Re: Proposed bicycle and pedestrian provision at the
Oxford & York Streets intersection, Bondi Junction

This advice concerns proposed works associated with the redevelopment of the building site at 194-214 Oxford Street Bondi Junction opposite the STA Waverley Bus Depot.

STC Drawing CPUD-01 sets out our recommendations for specific improvements to address access and safety issues mentioned above. These recommendations noted on the drawing are as follows:

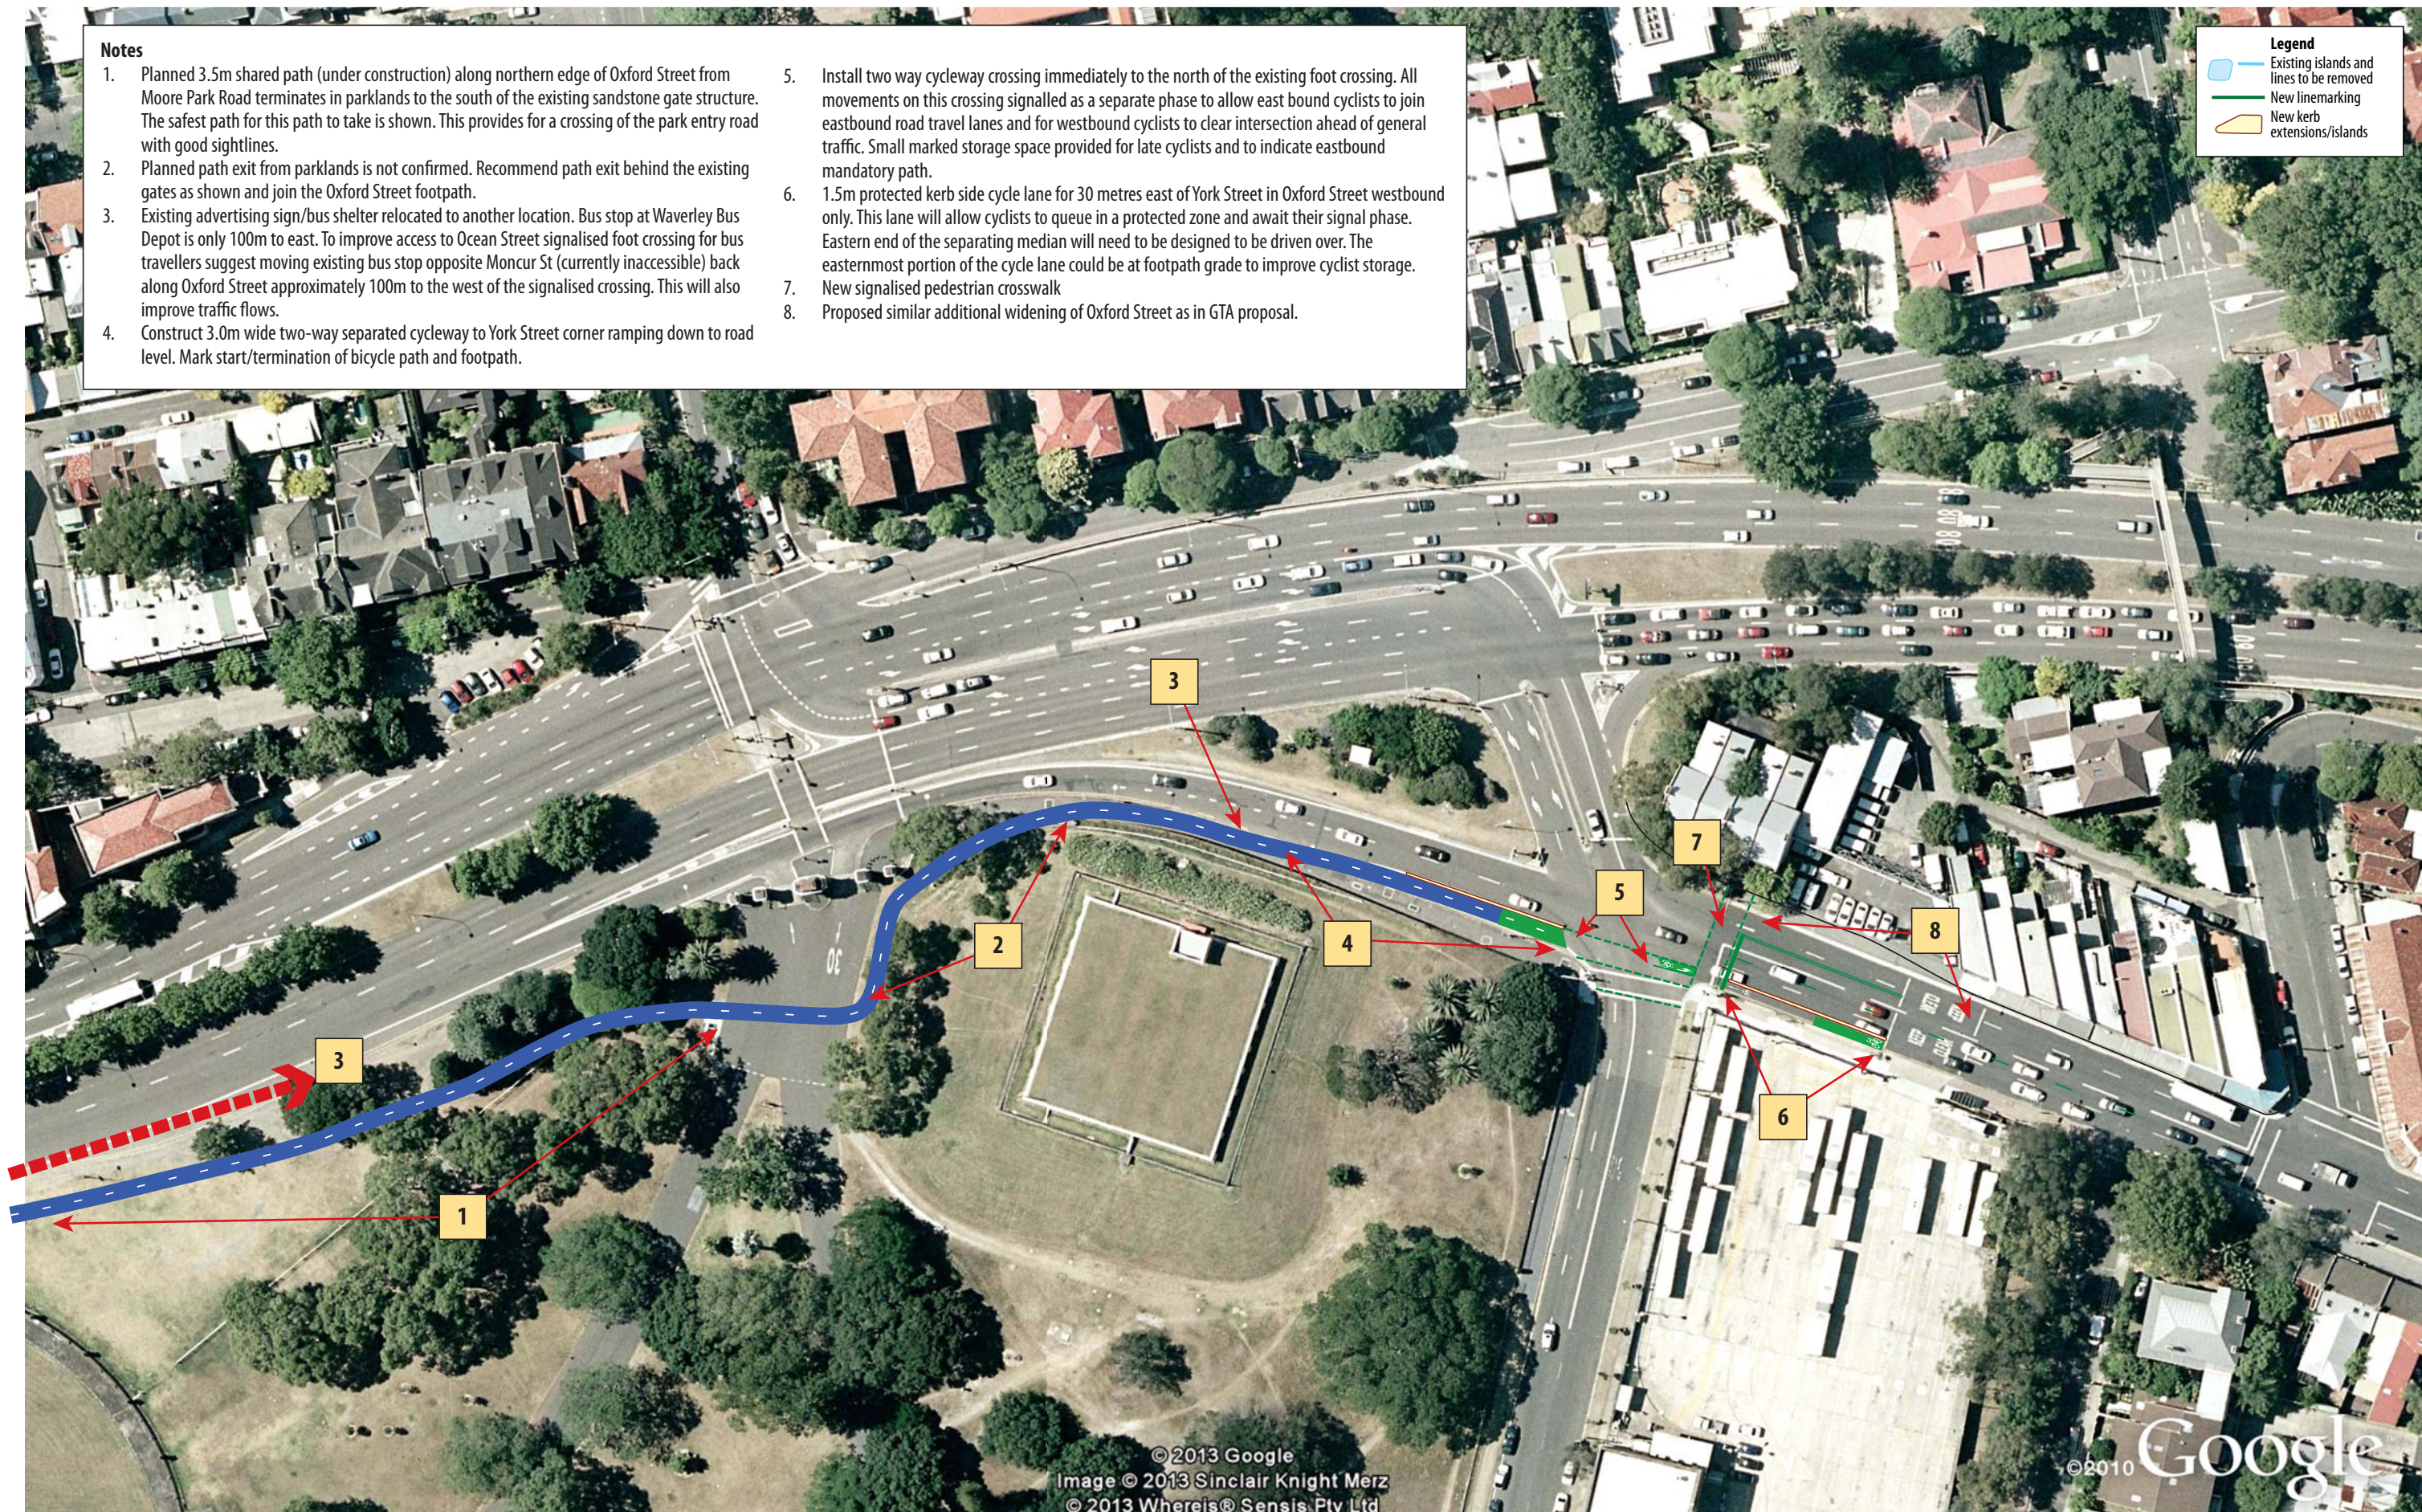
1. The drawing shows the route of the 3.5m shared path (under construction) along northern edge of Oxford Street from Moore Park Road. This path will terminate in the parklands to the south of the existing sandstone gate structure to avoid the squeeze point to the immediate north of the gate. The recommended safest path for this path to continue into the eastern portion of Oxford Street is shown on the drawing. This route provides for a crossing of the wide park entry road sufficiently set back from the park gates to achieve good sightlines.

2. The planned path exit from parklands has not been confirmed to this writer. The recommend path exit is to the east of the existing gates, joining the existing Oxford Street footpath.

3. The existing advertising sign/bus stop and shelter needs to be relocated to another location due to safety concerns and minimum safe path width considerations. The bus stop at Waverley Bus Depot is only 100m to east and provides access to far greater bus services. To improve access for bus travellers to the Ocean Street signalised foot crossing, we suggest moving the existing bus stop opposite Moncur St back along Oxford Street approximately 100m to the west of the signalised crossing. This bus stop is inaccessible to pedestrians living to the north of Oxford Street as there is no close-by controlled crossing of the Oxford Street six-lane divided carriageway.

4. From 50 metres west of the York Street corner a 3.0m wide two-way separated cycleway should be constructed with appropriate ramping. Alternatively this could be built at footpath grade by moving the kerbing, and linemarking appropriate separation on the pavement.

5. Install a two way cycleway crossing immediately to the north of the existing foot crossing. All movements on this crossing would be signalled on a separate phase to other traffic movements to allow east bound cyclists to join eastbound road travel lanes and for westbound cyclists to clear the intersection ahead of general traffic. A small marked storage space should also be provided for late cyclists and to establish bi-directional cyclist flows on both sides of the crossing.

6. Install a 1.5m wide protected kerb side cycle lane for 30 metres east of York Street in Oxford Street westbound only. This lane will allow cyclists to queue in a protected zone and await their signal phase. Eastern end of the separating median will need to be designed to be driven over. The design of this cycle lane and the protecting median will need to take into account the bus depot exit driveway. Designing this lane at footpath grade may also improve cyclist storage at the corner.

7. Install a new signalised pedestrian crosswalk across Oxford Street to remove the long detour and to activate the northern side of Oxford Street.
8. In the GTA Traffic Report dealing with traffic flow improvements at this intersection some widening of Oxford Street was recommended. The above recommendations include this widening. With careful redesign the above pedestrian and cyclist improvements may also be fitted into the existing road cross section by moving the road centreline 1.5m to the north and readjusting the linemarking.

1. Planned 3.5m shared path (under construction) along northern edge of Oxford Street from Moore Park Road terminates in parklands to the south of the existing sandstone gate structure. The safest path for this path to take is shown. This provides for a crossing of the park entry road with good sightlines.

2. Planned path exit from parklands is not confirmed. Recommend path exit behind the existing gates as shown and join the Oxford Street footpath.
3. Existing advertising sign/bus shelter relocated to another location. Bus stop at Waverley Bus Depot is only 100m to east. To improve access to Ocean Street signalised foot crossing for bus travellers suggest moving existing bus stop opposite Moncur St (currently inaccessible) back along Oxford Street approximately 100m to the west of the signalised crossing. This will also improve traffic flows.

4. Construct 3.0m wide two-way separated cycleway to York Street corner ramping down to road level. Mark start/termination of bicycle path and footpath.

5. Install two way cycleway crossing immediately to the north of the existing foot crossing. All movements on this crossing signalled as a separate phase to allow east bound cyclists to join eastbound road travel lanes and for westbound cyclists to clear intersection ahead of general traffic. Small marked storage space provided for late cyclists and to indicate eastbound mandatory path.

6. 1.5m protected kerb side cycle lane for 30 metres east of York Street in Oxford Street westbound only. This lane will allow cyclists to queue in a protected zone and await their signal phase. Eastern end of the separating median will need to be designed to be driven over. The easternmost portion of the cycle lane could be at footpath grade to improve cyclist storage.

7. New signalised pedestrian crosswalk
8. Proposed similar additional widening of Oxford Street as in GTA proposal.
